ITEM 1

ALTERATIONS TO FRONT ELEVATION, FRONT PORCH CANOPY, TWO STOREY REAR EXTENSION, RAISED PATIO AND PRIVACY SCREEN AND NEW VEHICULAR ACCESS (REVISED DRAWINGS RECEIVED 03.04.2024) AT 93 SYCAMORE ROAD, HOLLINGWOOD, CHESTERFIELD FOR MR D UNWIN AND MISS R SMYTH

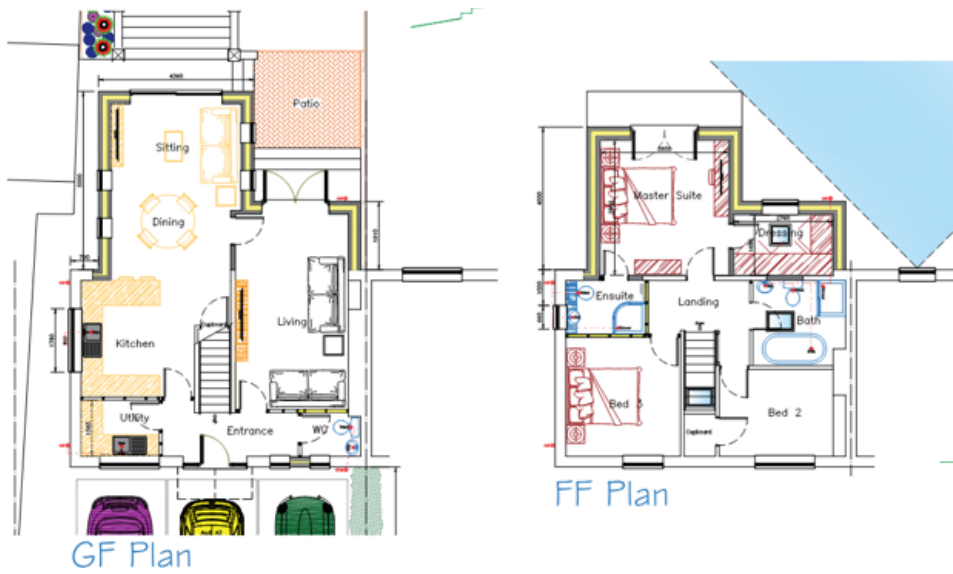
4.2 The Local Planning Authority raised concerns regarding the initial submission and the overall projection of the two storey extension and introduction of a dual pitched roof form with gable end. It was also highlighted that the plans appeared to suggest a level site with direct access to the garden level, however it is clear from the site that the ground slopes away and a raised platform or steps would be required to access the garden from the patio doors within the extension. Revised plans were subsequently submitted including a raised patio with privacy screens to the eastern and western boundaries.

4.3 The submitted revised plans reduced the rearward projection of the two storey extension to 4m at first floor with a hipped roof form to reduce the overall massing of the proposal. In addition the application description was amended in the interests of clarity with revised plans detailing a lower level patio, amended privacy screening and sections. In response to the comments made by the Local Highways Authority the entrance porch has been amended to be a cantilever canopy with supporting posts removed.

4.3 The application is therefore assessed on the basis of the revised plans. The revised plans propose a two storey rear extension formed of an 'L-shape' design with maximum rearwards projection of 5m at ground floor and 4m at first floor. The proposed extension will be

formed of a hipped roof form and flat roof component. The flat roof structure is situated adjacent to the adjoining property (No 91) and has a rearwards projection of 1.9m overall. The proposal will enable the internal re-configuration of the dwelling and will create a sitting/dining room to the rear with main bedroom and dressing room at first floor. The proposal will retain the current number of bedrooms (3 overall). The exiting porch will be replaced with an open timber structure. Alterations to the existing window arrangement are also proposed as indicated on the submitted plans.

Amended Site Plan

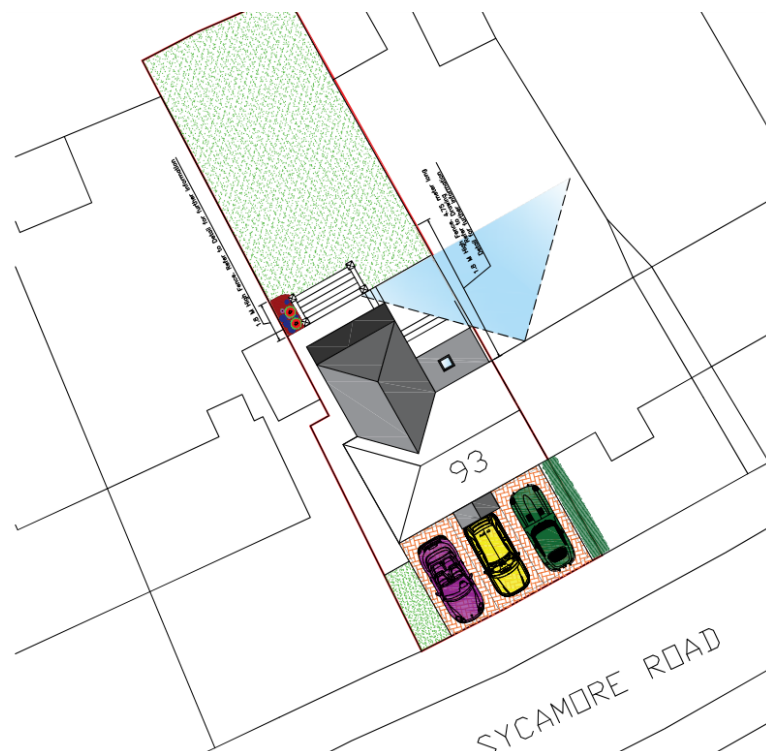
- 6.3.2 The application seeks consent for a two storey rear extension which has a maximum rearwards projection of 5m at ground floor. Potential impacts arising from the proposal are considered to be directed towards the immediate neighbours, of which letters of objections have been received from the three closest properties.
- 6.3.3 No 93 is the end property in a terrace of four two storey dwellings (No's 87 to 93 Sycamore Road). The terrace is uniform in character with consistent building line. To the west/north west of the site is No 95 Sycamore Road, a semi-detached two storey dwelling which is set back further north, creating a stepped building line. (see aerial photo below)

- 6.3.4 No 93 is elevated above No 95 which sits at a comparatively lower level. Additional separation is evident between No 93 and 95 with an existing detached flat roof outbuilding serving No 95, situated adjacent to the western boundary of the application site. The site also slopes away towards the northern boundary and as such the host dwelling is elevated above the garden level.
- 6.3.5 The application has been revised in response to concerns raised by the Local Planning Authority regarding the scale of the extension. The roof form of the extension was amended to a hipped design to reduce the massing and scale of the proposal and the first floor footprint was set back by 1m to limit adverse impacts of overshadowing.

- 6.3.6 The first floor of the two storey extension will extend approximately 1.3m beyond the rear elevation of No 95 (taken from the original rear elevation of No 95) and with a separation distance of approximately 3.5m between the existing side wall of No 95 and the proposed side wall of No 93. It is acknowledged that the proposal will have an impact on No 95 in terms of light with a degree of overshadowing to the east as the sun rises until it passes the extension. The projection of the extension of 1.3m at first floor beyond the rear of No 95 is considered to be an improvement on the original submission, combined with the introduction of a hipped roof form to reduce the overall height and massing of the proposal. Whilst the scheme is considered to be on the upper limits of acceptability, on balance the revised plans are considered to be acceptable.

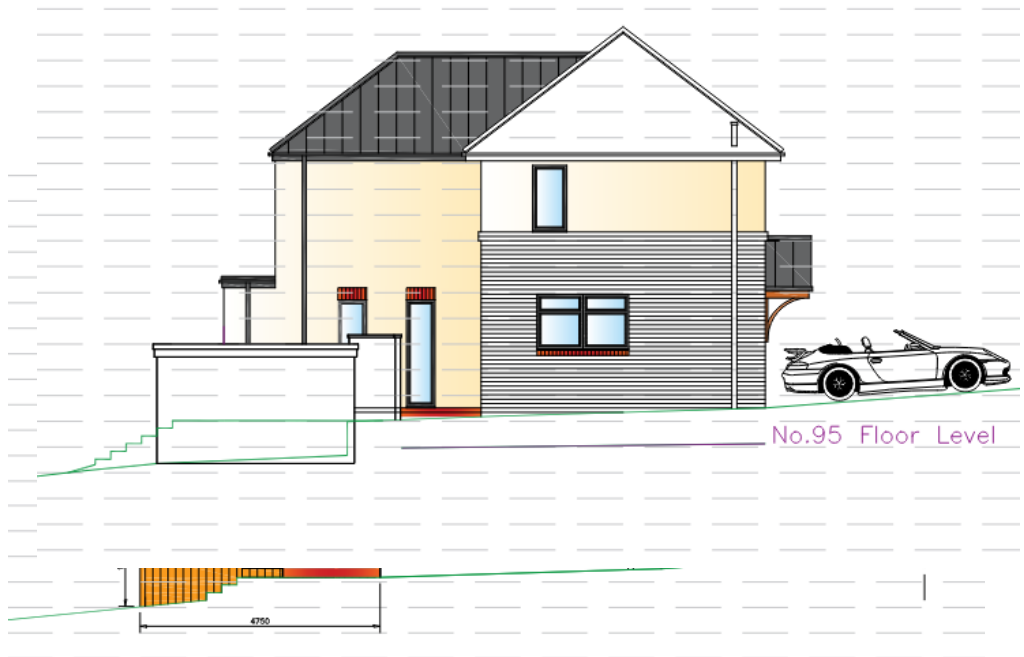
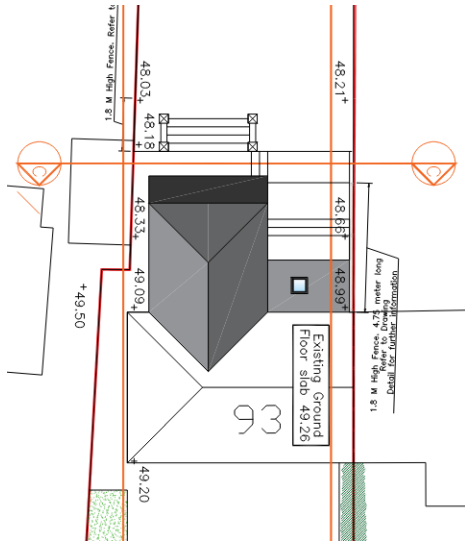
- 6.3.8 In response to concerns raised by the Local Planning Authority the propose raised patio has been reduced considerably with steps down from the house to a lower level as illustrated on the submitted sections. To protect the amenity of the adjoining neighbours a 1.8m high privacy fence is proposed to prevent overlooking from the patio and new extension. The introduction of a fence will have a visual impact for the neighbours given that the existing boundary is currently approximately 1m high. The fencing will also be elevated due to the additional height created by the raised patio see submitted elevational drawings below;

- ***Fencing and loss of privacy from raised patio – concerns regarding height and scale of fencing noted. The revised scheme includes an amended patio design to reduced the length of privacy screening required. It is necessary to note that under permitted development rights householders can install fencing up to 2m in height on the boundary without requiring planning permission. The patio will be required to have privacy screening up to 1.8m in height to protect the privacy and amenity of the neighbours.***
